**INVITATION TO BID: No. ITB/RBAP/2021/001  
FOR THE ESTABLISHMENT  
OF A FRAME AGREEMENT FOR THE SUPPLY OF  
MULTI-PURPOSE SOLAR LAMP**

**QUESTIONS AND ANSWERS**

**Round 3 (Last round) - issued on 28 October 2021**

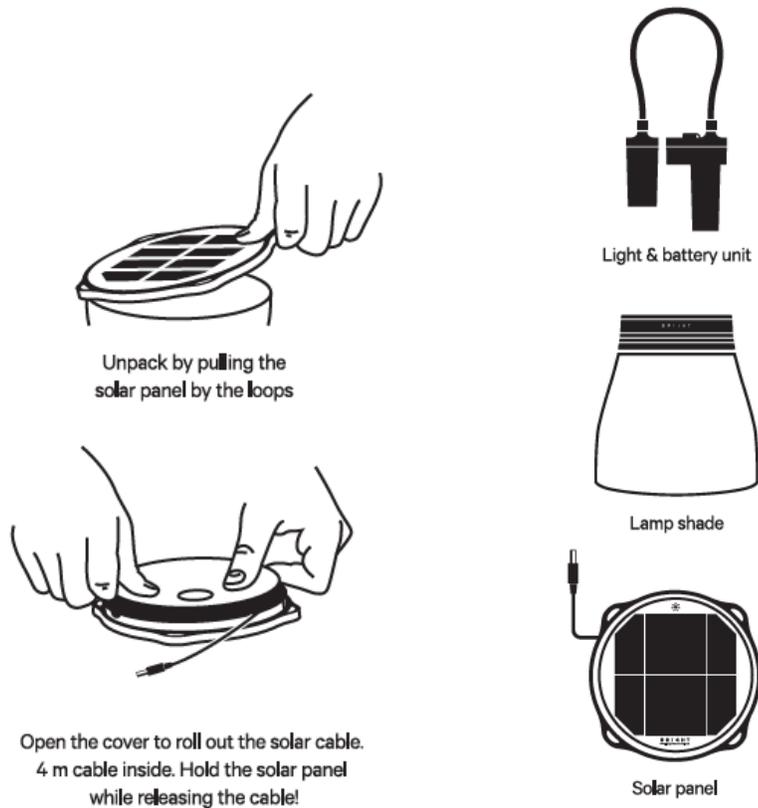
17. Can you please send the vertical, top, and bottom view of the lamp? We would like to know where the solar panel is installed.

**UNHCR Answer:** The external solar panel is included in the package with another components. Please see below illustration picture of the solar lamp for your reference.
